HISTORIC AND DESIGN REVIEW COMMISSION

Agenda Item No: 26

HDRC CASE NO: 2015-181
ADDRESS: 700 W COMMERCE ST
LEGAL DESCRIPTION: NCB 299 BLK 24 LOT 1 THRU 14
ZONING: D H HS
CITY COUNCIL DIST.: 5
DISTRICT: Cattleman Square Historic District
LANDMARK: Toudouze Market & Buildings 2, 3, and #4
APPLICANT: STG Design
OWNER: Michael Wilbracht/210 Developers
TYPE OF WORK: New construction
REQUEST:

Construct a mixed-used development at the 700 block of W Commerce to include 242 residential units, ground floor retail and podium parking. The historic Maureaux Building which housed the Toudouze Market will be partially demolished to retain the south and east facades of the building. The ground floor storefront and canopy is proposed to be replaced / reconstructed.

SOUTH ELEVATION - W.COMMERCE ST.

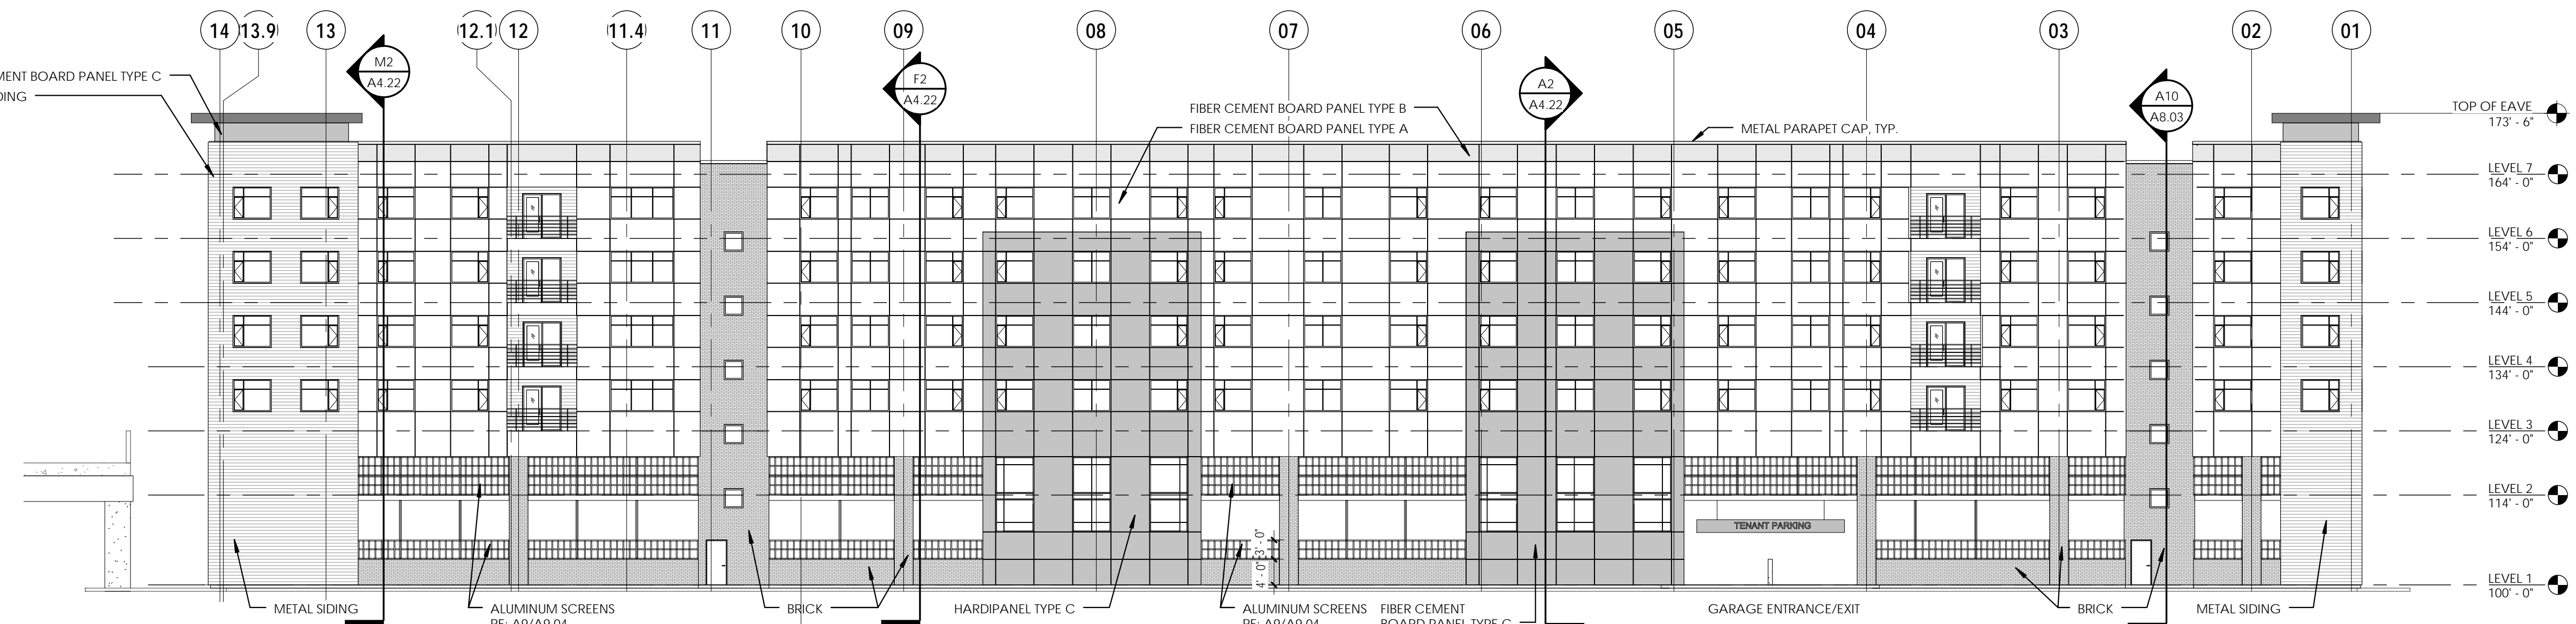
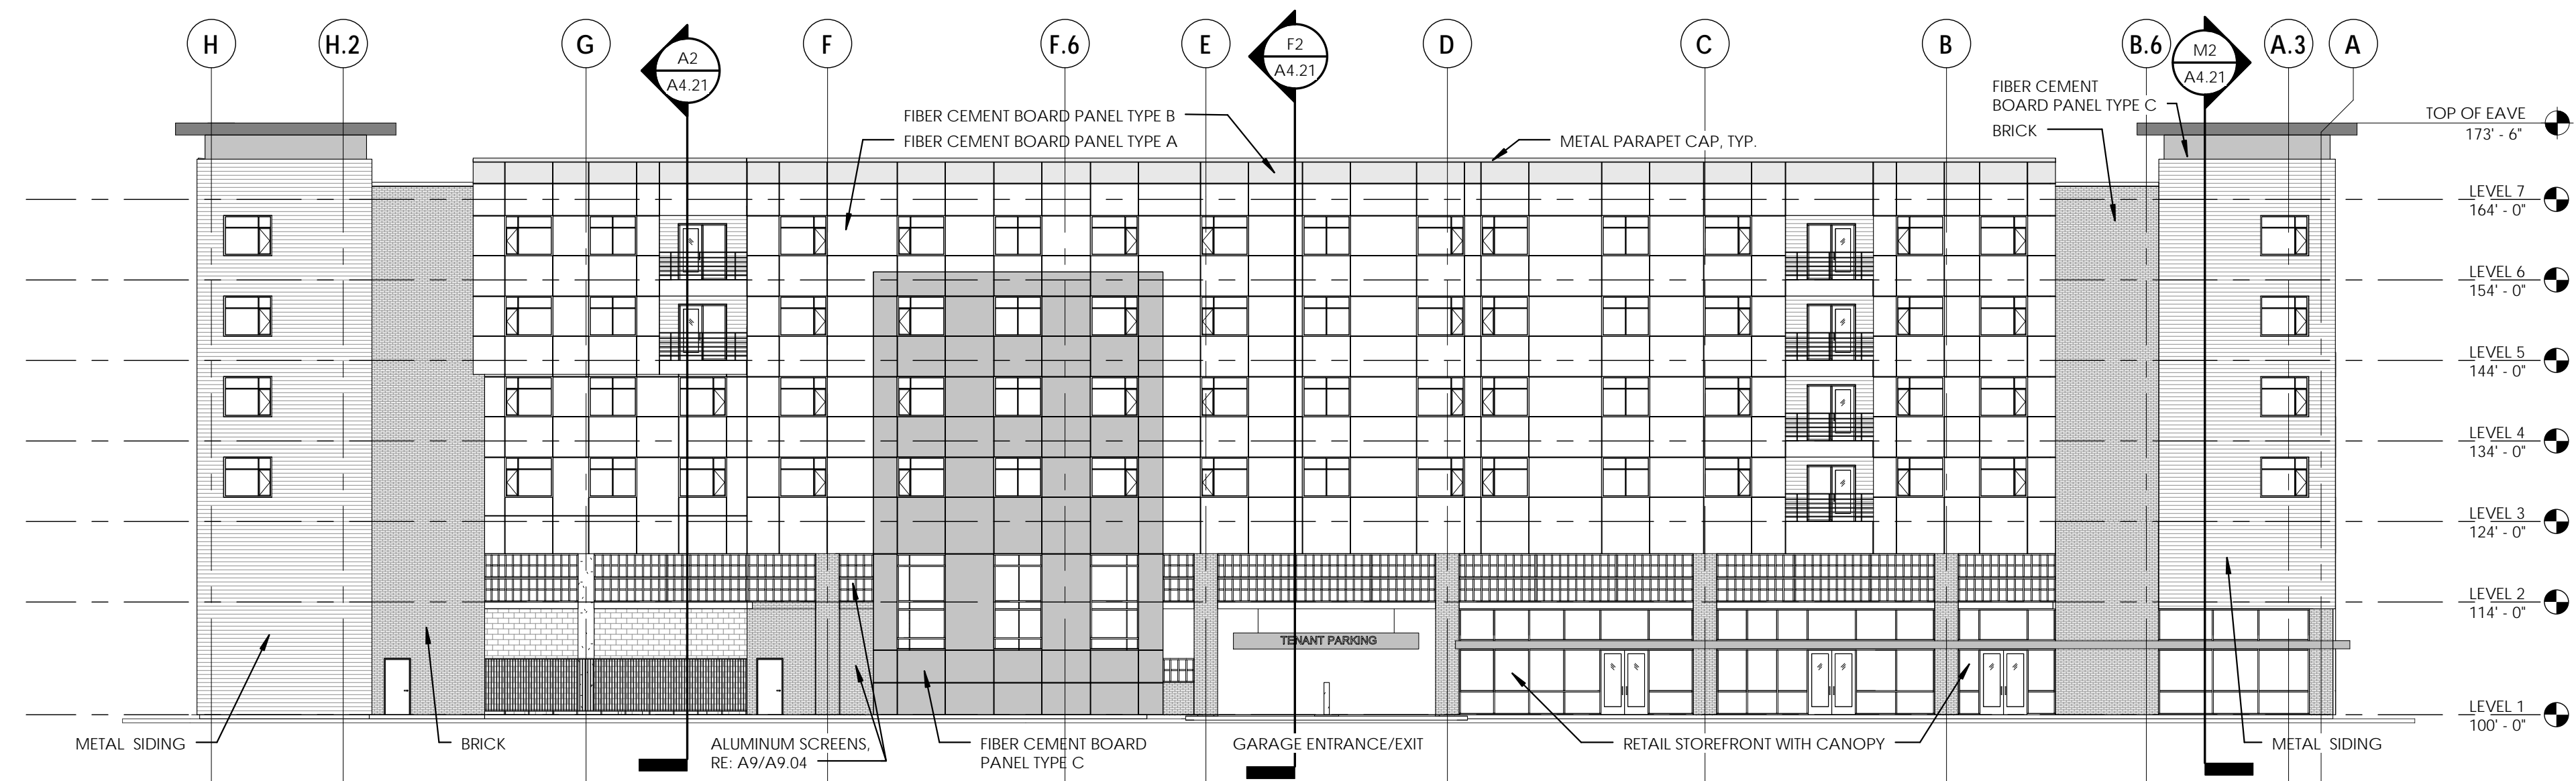
- l. According to the Guidelines for New Construction 2.C.ii., horizontal façade elements should align with those found in nearby historic buildings. A base, middle and cap should be established to conform to the established precedent. In elevation drawings submitted, there appears to be an established base articulated by an overhead canopy. A cap has been articulated by a change in materials along the parapet and at the corners of the building. The middle of the façade is further articulated by projecting bays featuring an alternate material.

- m. According to the Guidelines for New Construction 3.A.i., new materials should complement the type, color and texture of materials traditionally found in the district. Brick masonry is the most common material found in the Cattleman’s Square Historic District. Exterior materials specified in the request include hardie panel and metal siding. These materials have no historic context within the district and should be used in limited quantities. The applicant has presented additional options for exterior cladding materials, including hardie panel, hardie plank, stucco and metal siding. While the use of stucco is appropriate, staff find that brick should be the predominant façade material.

- i. That the applicant study ways to further incorporate brick into the proposal, particularly brick that complements that of the Maureaux Building prior to receiving a Certificate of Appropriateness.
- ii. That the excavations meet all requirements for archaeology outlined in UDC Article 6, Sections 35-630-35-634, 35-675, and 35-606.

A1 SOUTH ELEVATION - MAUREAX BUILDING
1/4" = 1'-0"

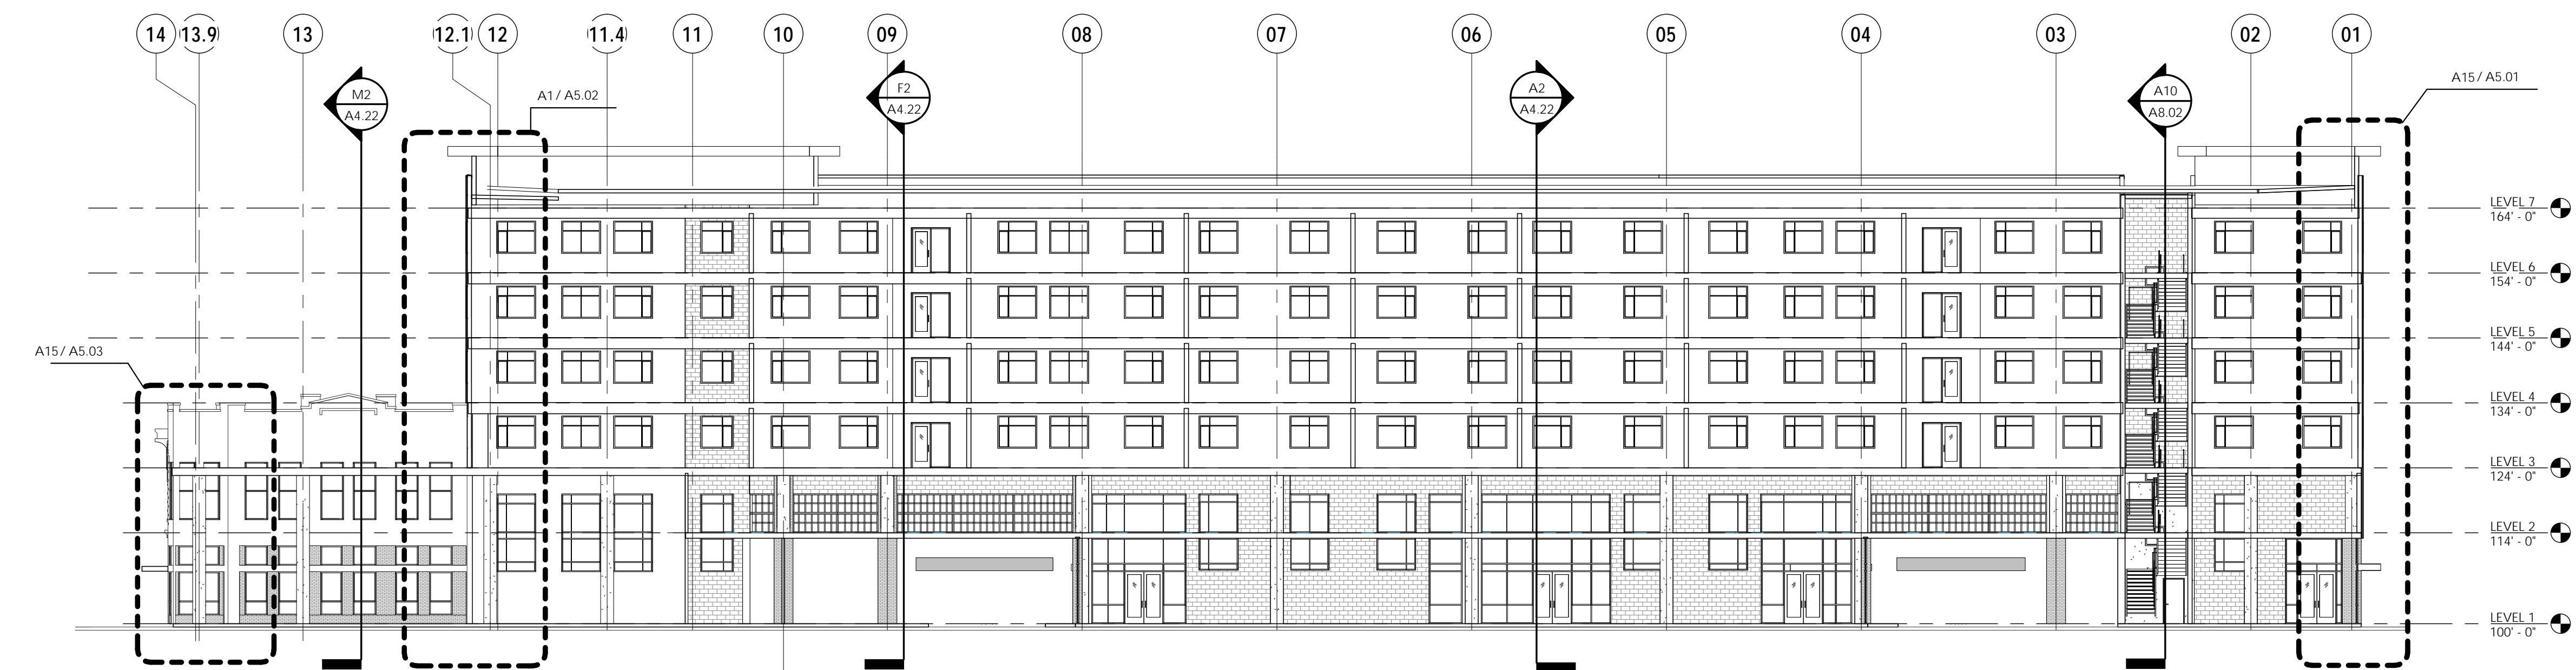
- q. According to the Guidelines for Exterior Maintenance and Alterations 10.B.ii., commercial storefronts should be restored based on photographic evidence. The proposal reintroduces a canopy to the storefront. Additionally, at the suggestion of the HDRC, the applicant has indicated that the columns at the ground level will be restored using matching brick. The ground level storefront has been modified, so the current proposal will be an improvement consistent with the Guidelines. Further restoration of the historic storefront based on photographic evidence could serve to mitigate the partial demolition of the structure.
